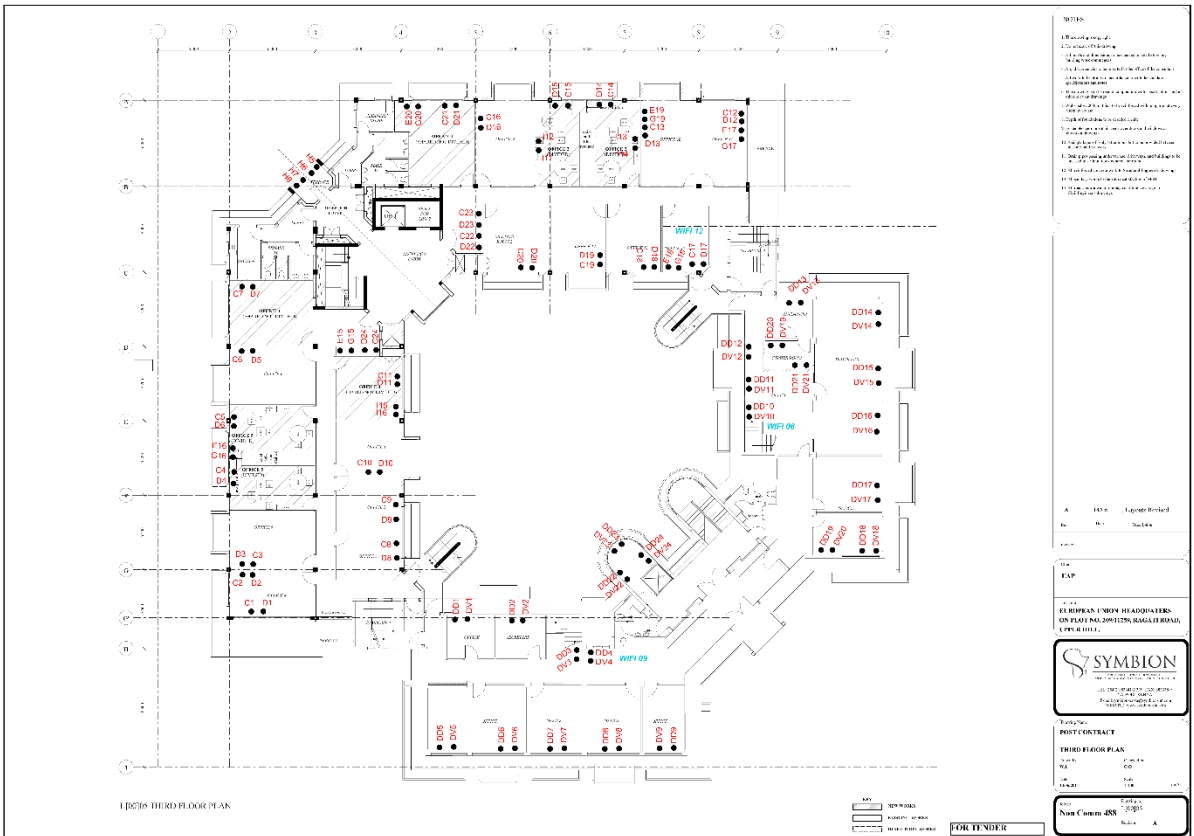
5. Following the site visit undertaken on 13th February, kindly provide floor plans of the site to assist in cable and trunking estimation.

10. You have requested we come up with a proposed design of the IP CCTV, Access Control & Intruder Alarm System, please provide us with a floor layout of the building so that we can be able to come up with the designs as it was not shown in the tender document?

THE FLOOR PLANS ARE ATTACHED AT THE END OF THIS CLARIFICATION. KINDLY ZOOM ON THE MAPS FOR CLARITY.
